ARCHITECTURAL REVIEW BOARD

PROPOSAL: To develop a 10-unit Apartment

LOCATION: Southeast corner of 18th and "U" Streets

APPLC. NO. 79-31

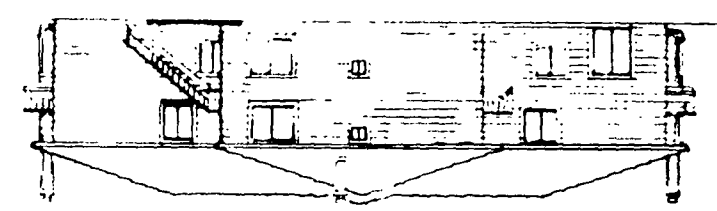
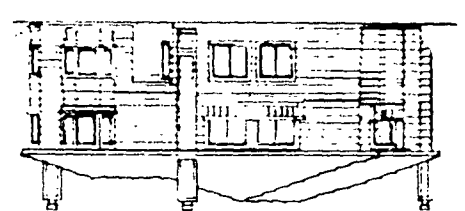
1. The horizontal siding should be continued to the east and south elevations for continuity.
2. An island planter shall be designed around the large tree in the parking lot (See exhibit A).
3. A planting strip shall be designed between the alley and parking area.
4. The staff measured the two adjacent structures and determined the average setback to be 14 feet. Therefore, the applicant must provide a minimum 14 feet front setback.

1. The front setback on "U" Street shall be the average of the two adjacent structures or approximately 14 feet.
2. The applicant shall redesign the site plan as indicated by exhibit A (island planter and planter strip).
3. The horizontal siding shall be continued to the east and south elevations.
4. A detailed landscape plan shall be submitted to staff for review and approval.
